BOWERS LANE SUBDIVISION, RESUBDIVISION OF LOTS 1-3, SULLIVAN'S ADDITION TO

Engineering Comments: The following comments should be addressed prior to submitting the FINAL PLAT for acceptance and signature by the City Engineer:

APPLICATION NUMBER 6 DATE November 6, 2014
APPLICANT Bowers Lane Subdivision, Resubdivision of Lots 1-3, Sullivan's Addition to
REQUEST Subdivision

DETAIL SITE PLAN

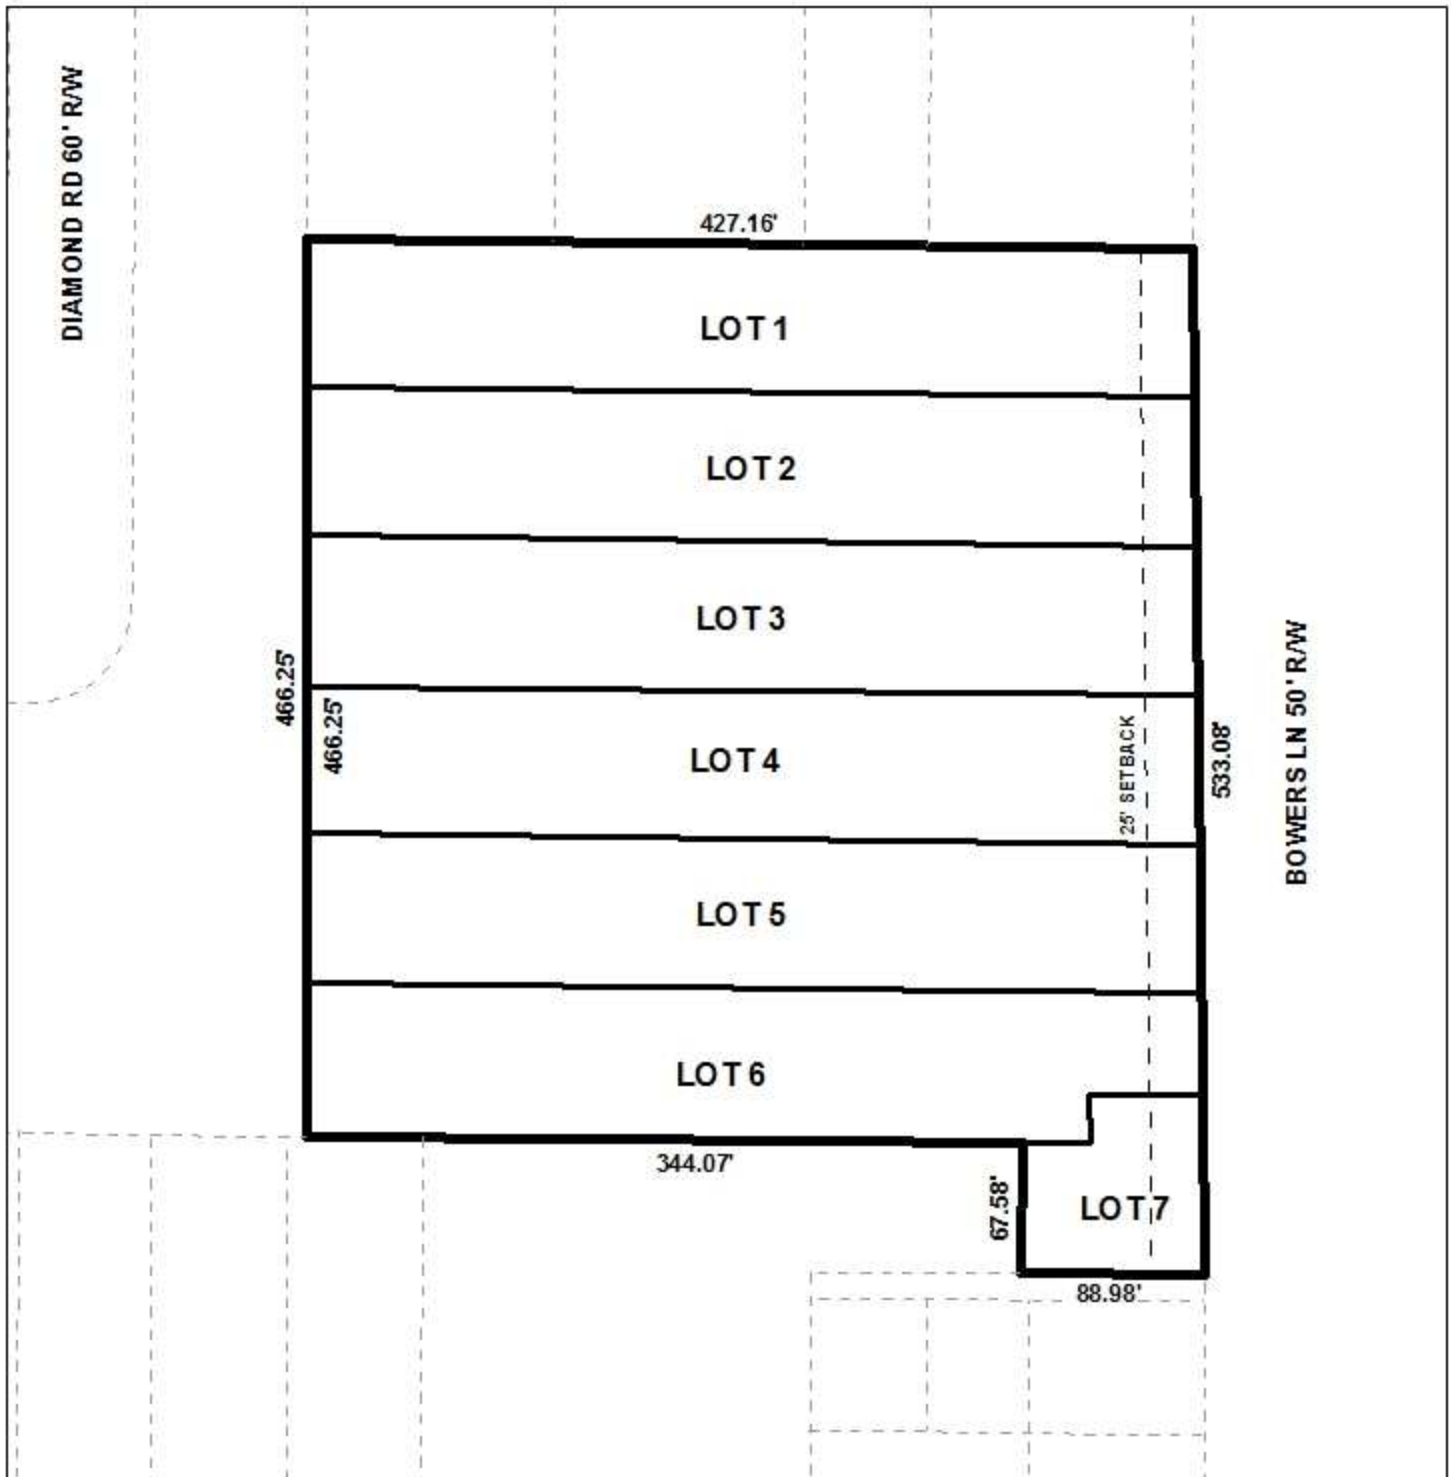
The site has frontage onto Bowers Lane, a minor street, with no curb and gutter. As such, Bowers Lane should have a right-of-way of 60'. The preliminary plat illustrates an existing right-of-way of 50', making dedication to provide 30' from the centerline necessary, if approved.

It should be noted that the proposed Lots 1-6 do not meet the standards for width-to-depth ratio. Section V.D.3. of the Subdivision Regulations states that lot depth should not exceed 3.5 times the width of the lot at the building setback. Thus, the typical proposed 77.54 \pm foot wide lot should only be 271 \pm feet deep, rather than the 429 \pm feet proposed. The Planning Commission waived Section V.D.3 and approved a Subdivision of the majority of this site into three lots at its August 6, 2009 meeting, however, the narrowest lot was 132 \pm feet in width, thus the width to depth ratio difference was minor.

The proposed Lot 6 has less than 60' of street frontage as required by Section V.D.2. of the Subdivision Regulations. There is one metes-and-bounds parcel in the area that has less than 60' of street frontage, and none that the Planning Commission has approved. Furthermore, the applicant provides no justification for the reduced frontage. The proposed property lines could be adjusted slightly to provide 60' of frontage for all proposed lots.

- 1) The proposed Lot 6 does not provide the minimum amount of street frontage required by Section V.D.2. of the Subdivision Regulations; and
- 2) Proposed Lots 1-6 do not meet the standards for width-to-depth ratio contained in Section V.D.3. of the Subdivision Regulations.
